CITY OF LOS ANGELES
INTER-DEPARTMENTAL CORRESPONDENCE

3440 Wilshire Blvd
DOT Case No. CEN 16-44755

Subject: **TRANSPORTATION ANALYSIS FOR THE PROPOSED MIXED-USE PROJECT LOCATED AT 3440 WILSHIRE BOULEVARD**

ATTACHMENT 3 Project Site plan

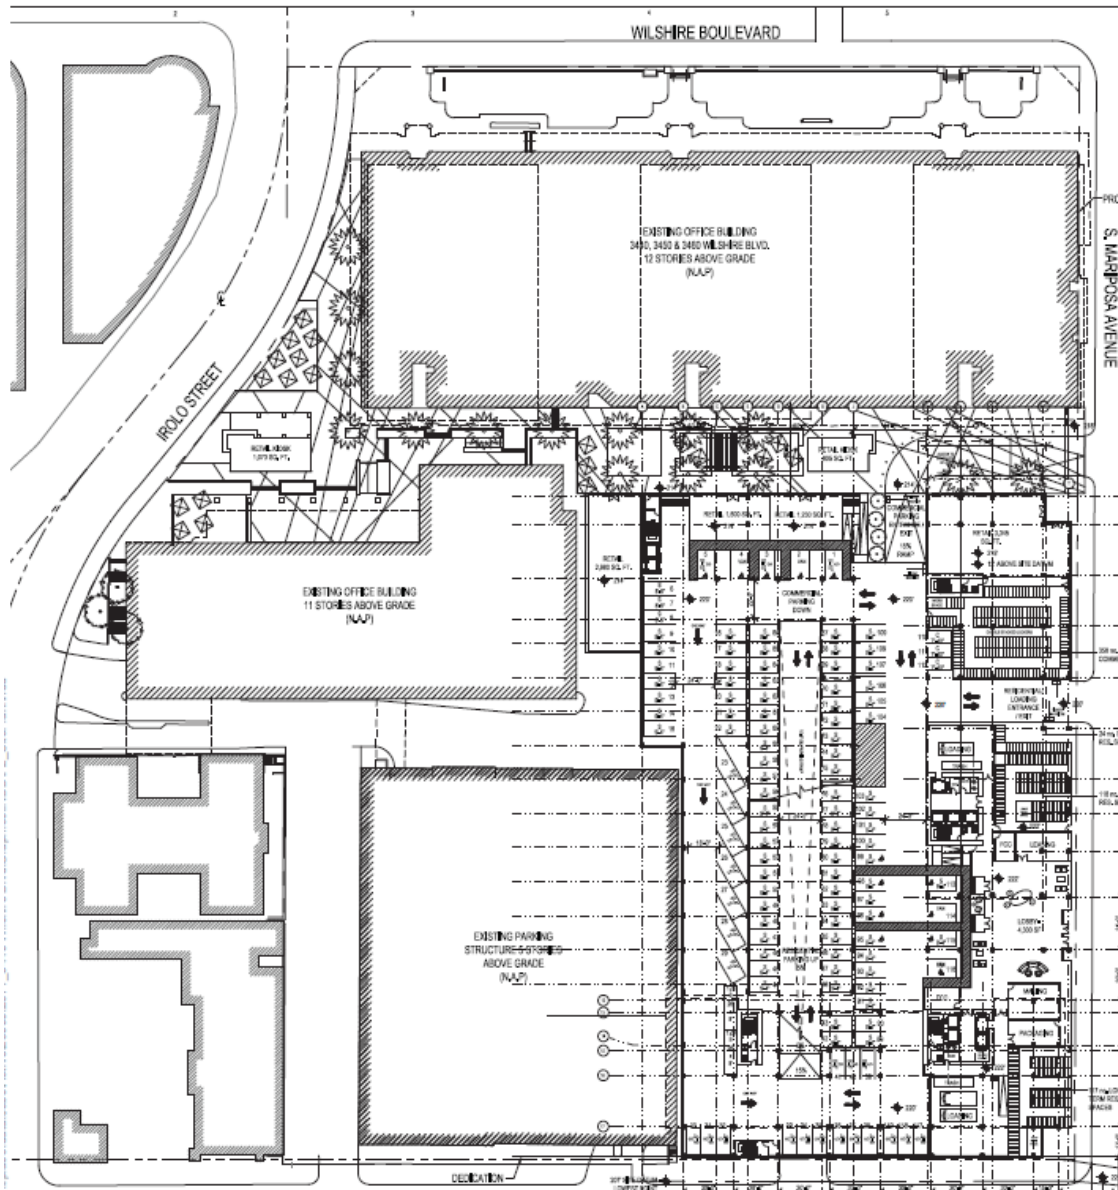
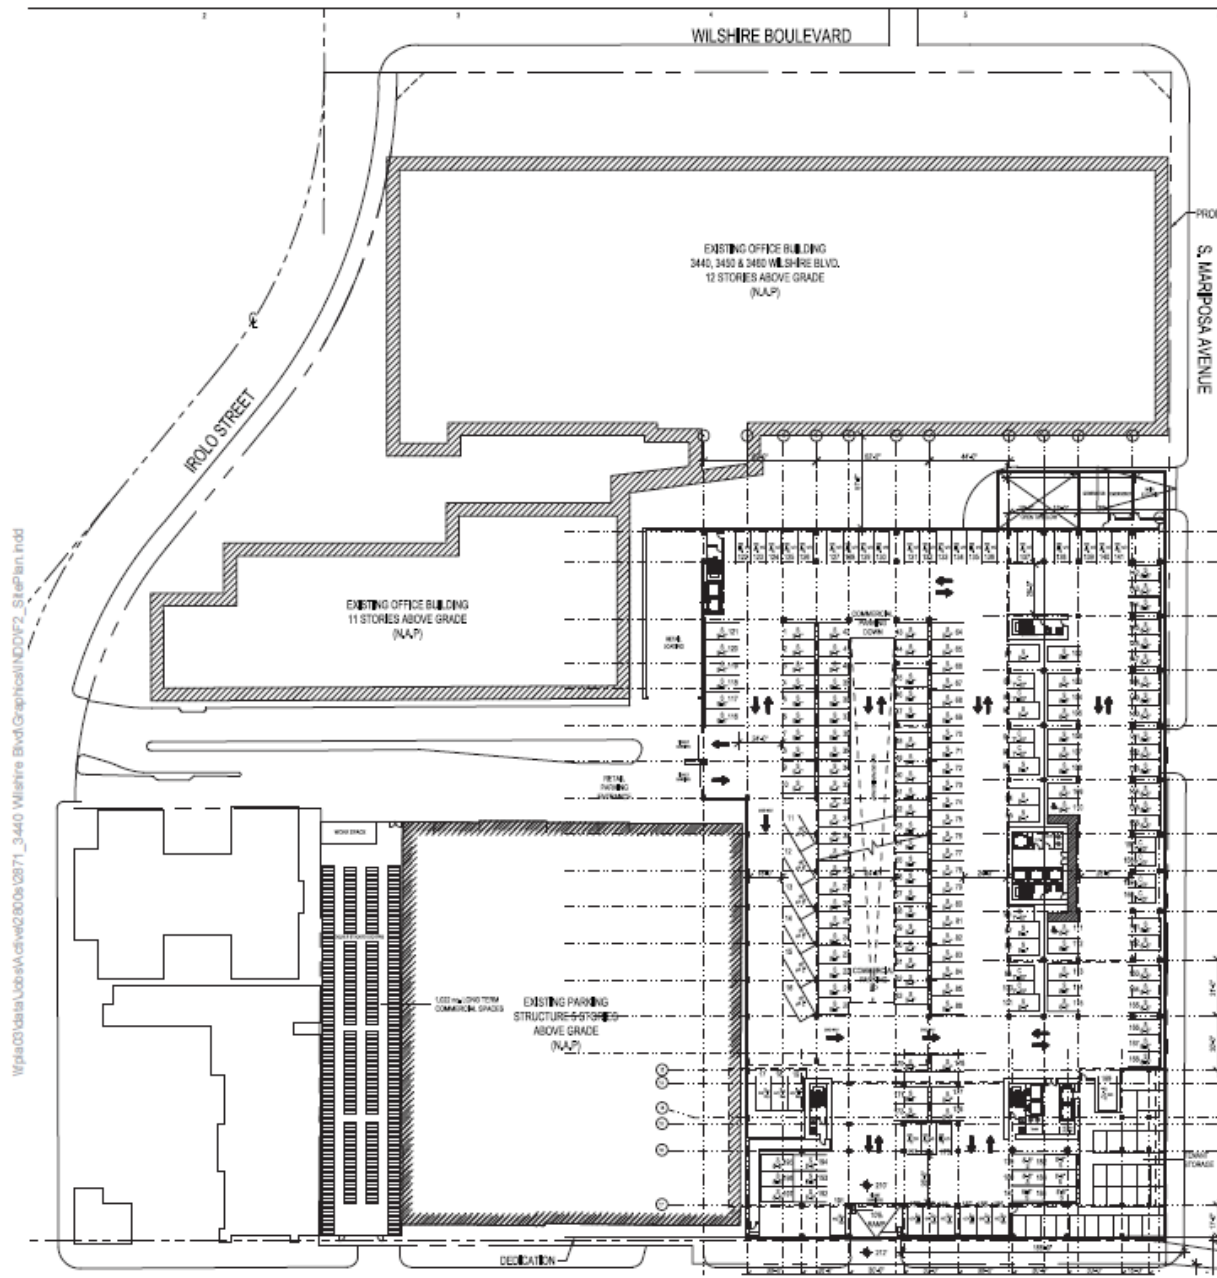
The proposed site plan illustrated in **Attachment 3** is acceptable to DOT; however, review of the study does not constitute approval of the driveway dimensions and internal circulation schemes. Those require separate review and approval and should be coordinated with DOT's Citywide Planning Coordination Section (201 N. Figueroa Street, 5th Floor, Room 550, at 213-482-7024). In order to minimize potential building design changes, the applicant should contact DOT for driveway width and internal circulation requirements so that such traffic flow considerations are designed and incorporated early into the building and parking layout plans. All new driveways should be Case 2 driveways and any security gates should be a minimum 20 feet from the property line. All truck loading and unloading should take place on site with no vehicles backing into the project via any of the project driveways.
